Portugal Street East, The Fairfax

Design Justification Statement

The following presentation has been produced to set out the developed design compared to the approved planning drawings. The drawings are all labelled with reference to Schedule 1.0 which sets out the design revisions.

Block 2, North East Elevation - Proposed Design

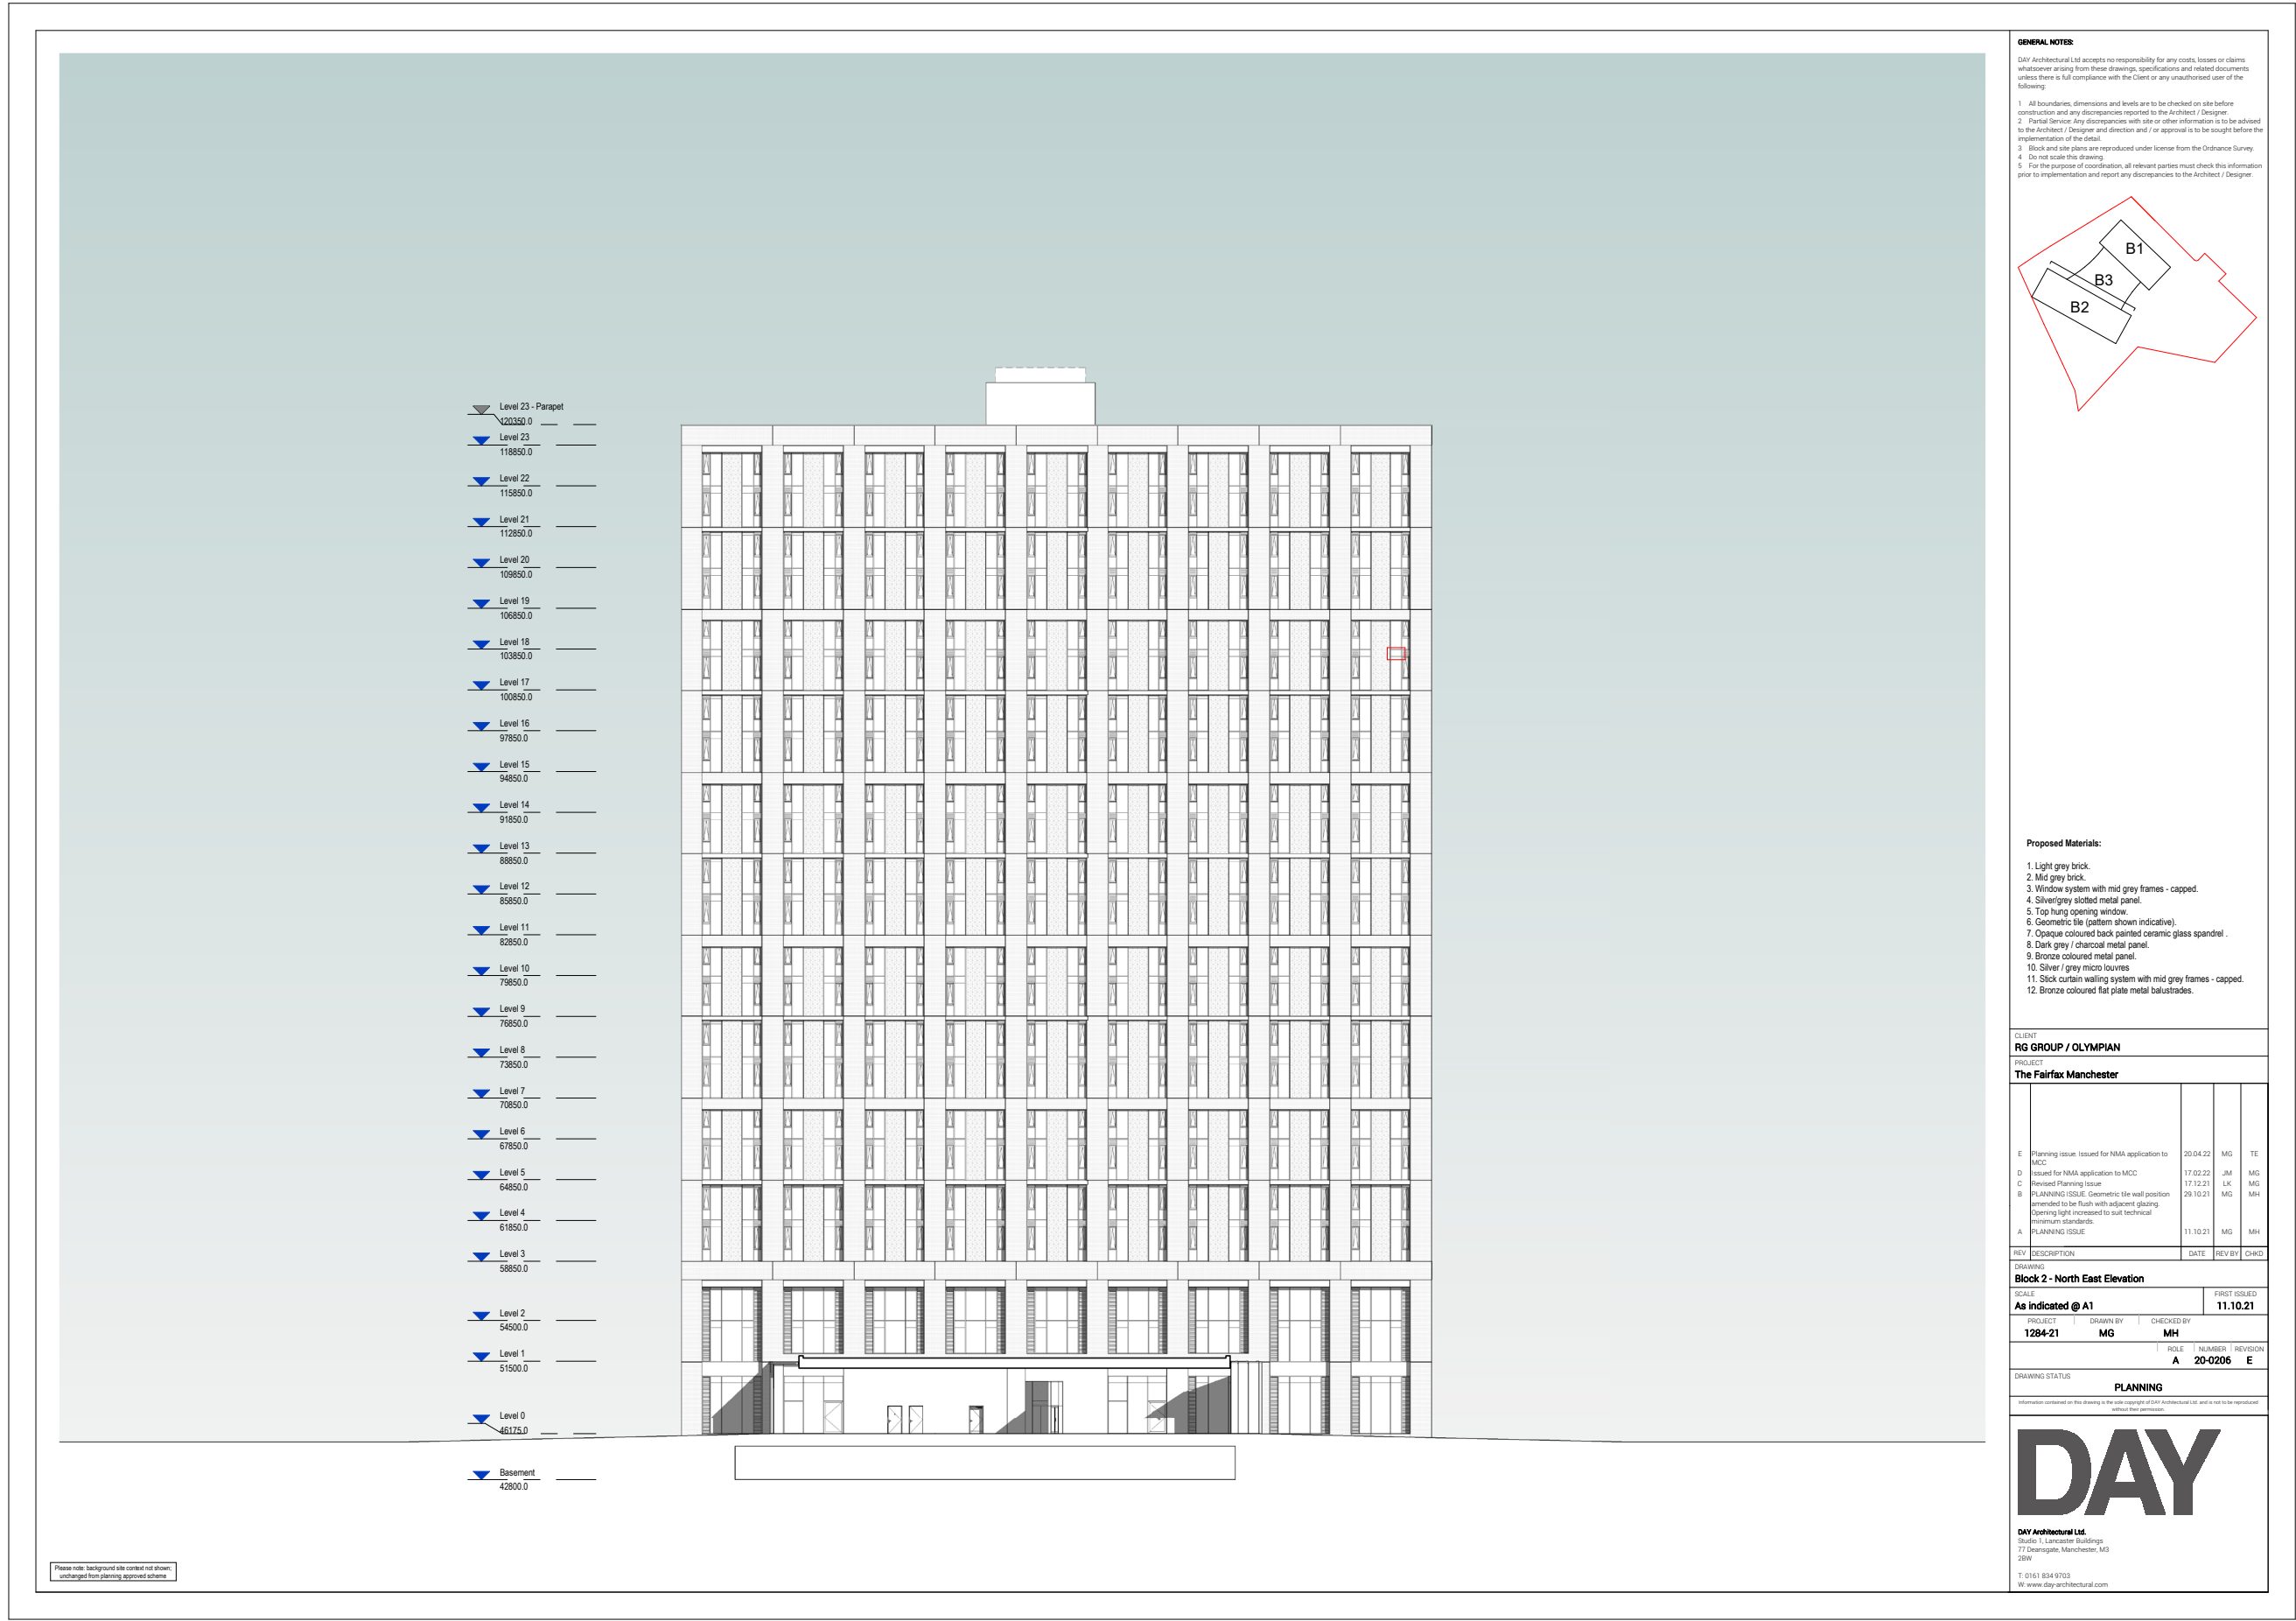
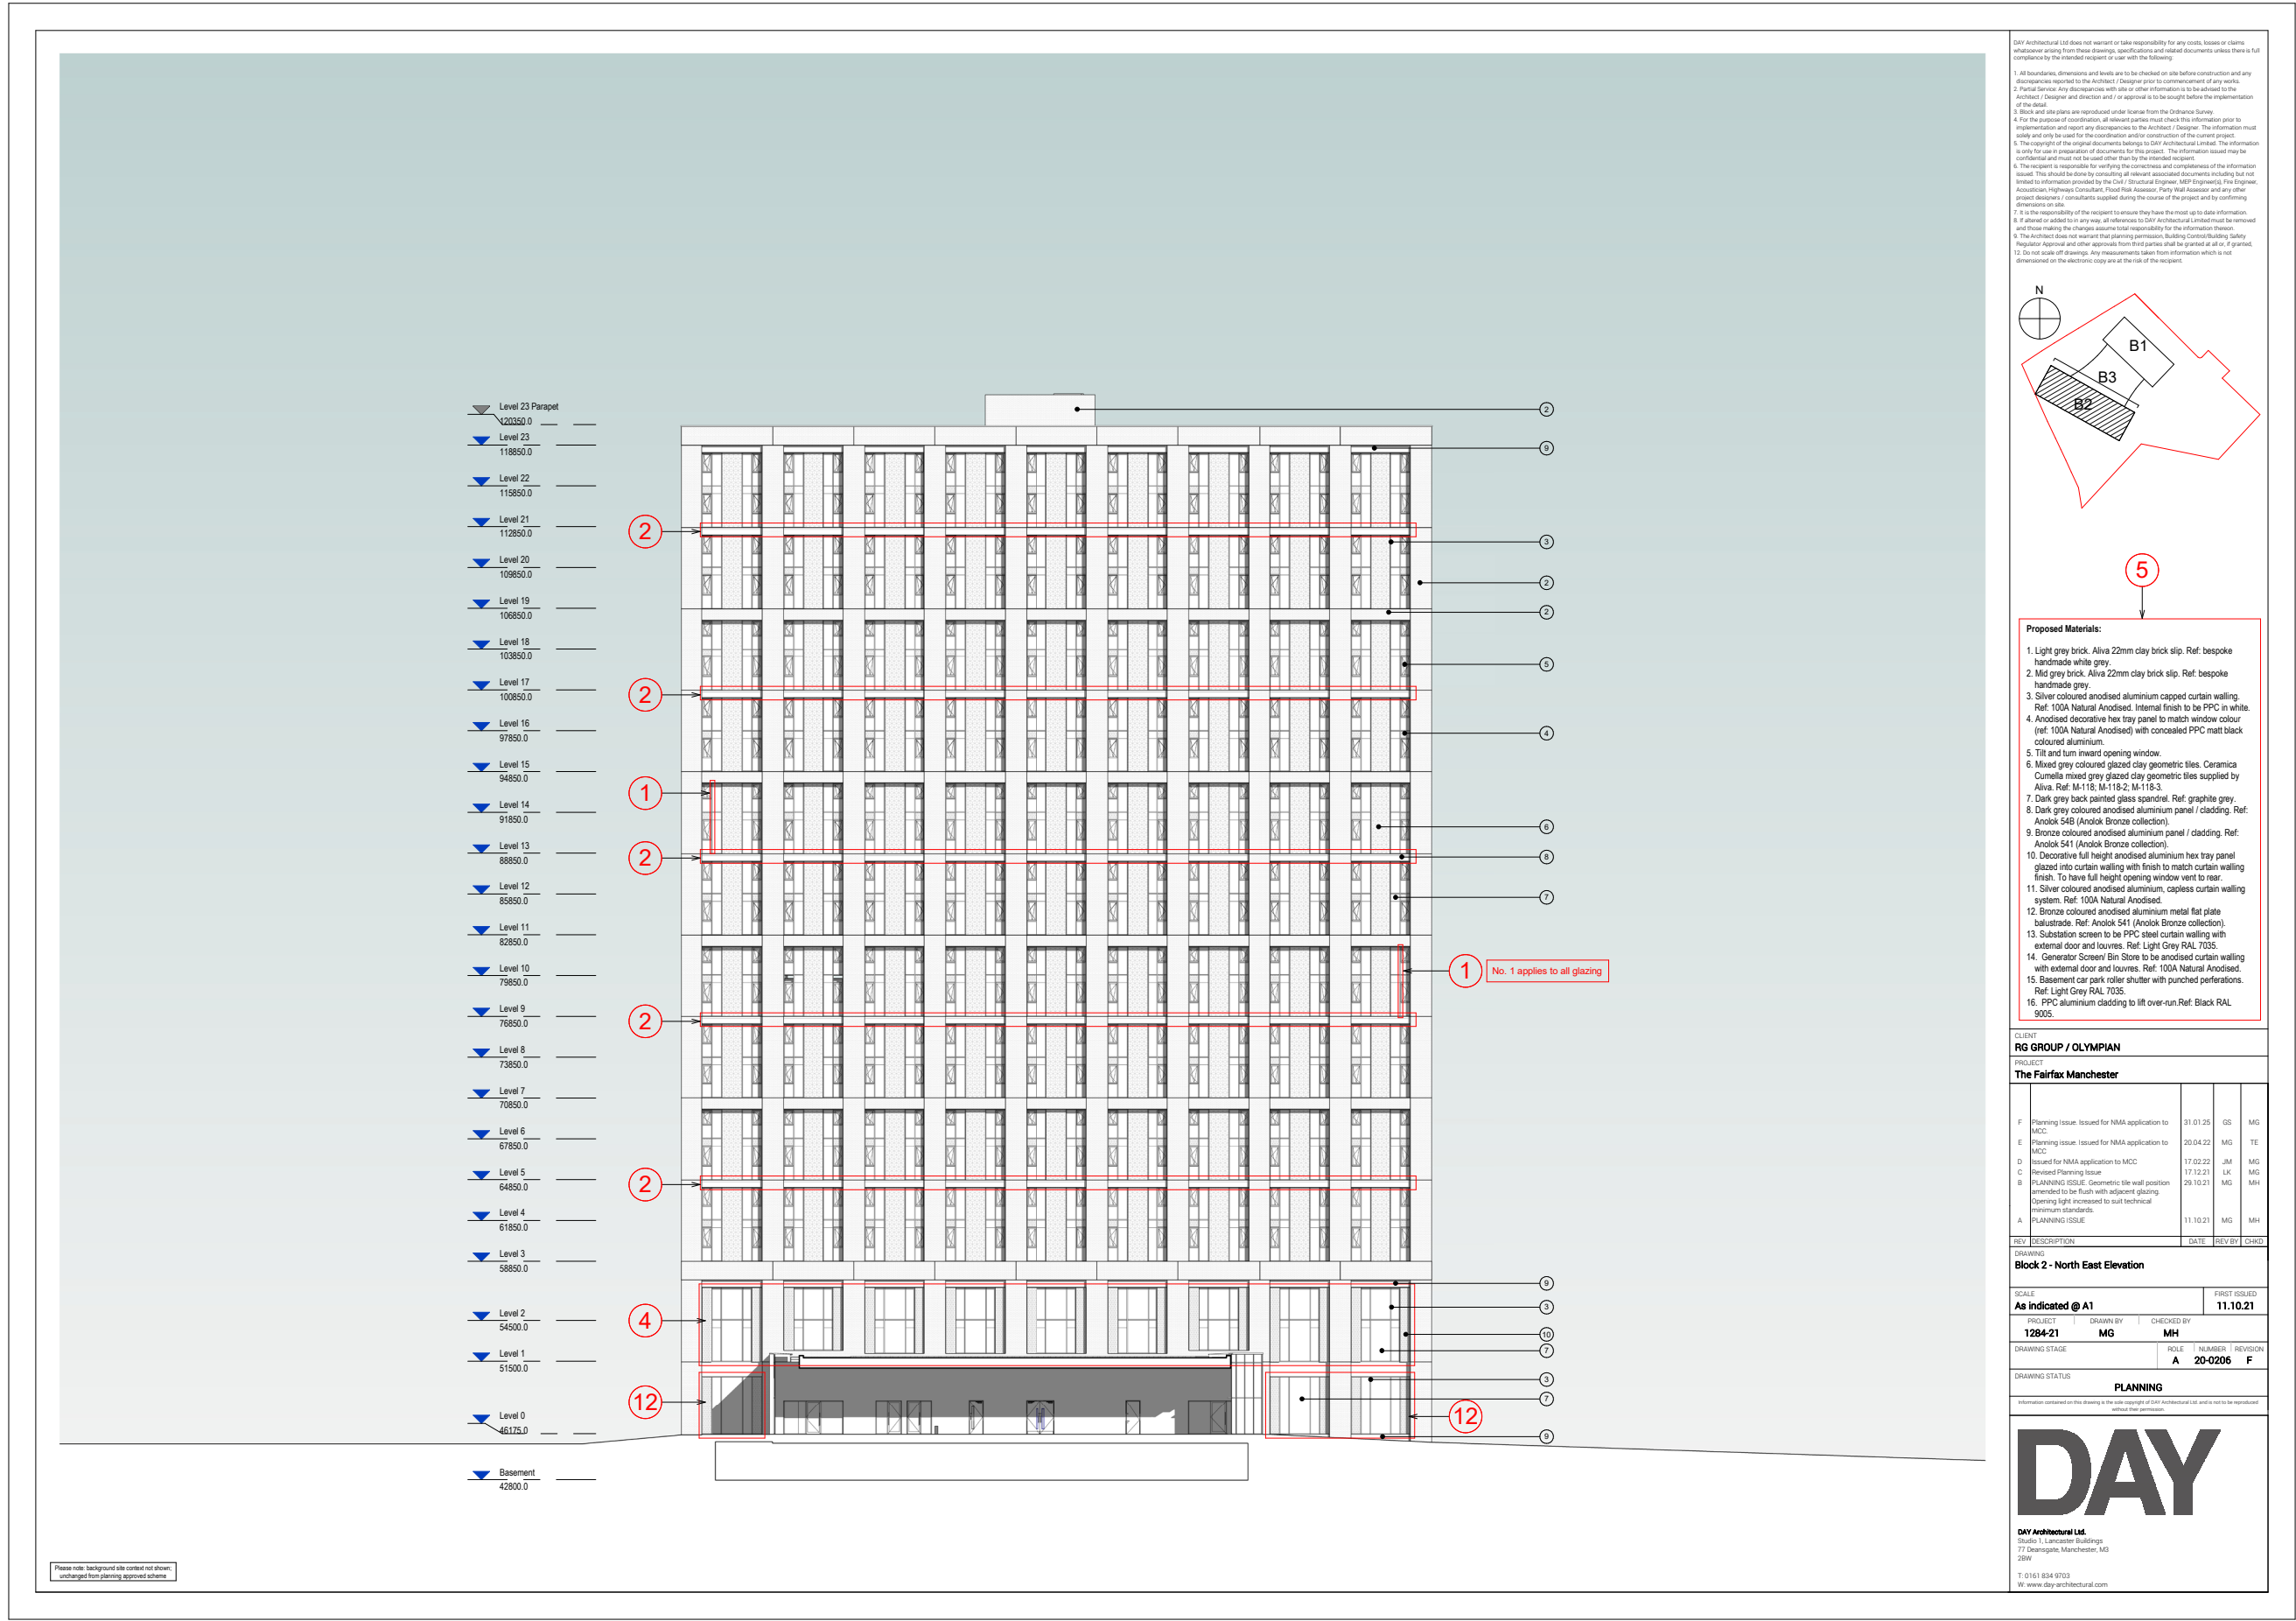
2	Block 2 external walls	Height of the feature charcoal metal banding to Block 2 increased in height from 300mm to 525mm from Level 3 upwards. Metal banding reveal has also decreased to 150mm in accordance with approved sample panel.	Due to the inherent design of the Block 2 elevations, the mechanical ventilation zone on the facades is halved every four stories due to the introduction of the 300mm deep charcoal band, which in turn halves the free area achieved by the ventilation and MVHR system. Due to the reduced area, it is not feasible to provide sufficient mechanical ventilation without finding additional ventilation area on the facades The charcoal band is recessed from the front face of the primary brickwork, and is in a darker grey than the brickwork The height of the charcoal band is increased to provide sufficient space to enable the mechanical ventilation route to be included within the metal banding, and allow for the intake / extract vents to be located to the underside of the banding	20-0201 REV F 20-0202 REV F 20-0205 REV E 20-0206 REV E 20-0304 REV E 20-0305 REV E 20-0307 REV E	20-0201 REV G 20-0202 REV G 20-0205 REV F 20-0206 REV F 20-0304 REV F 20-0305 REV F 20-0307 REV F
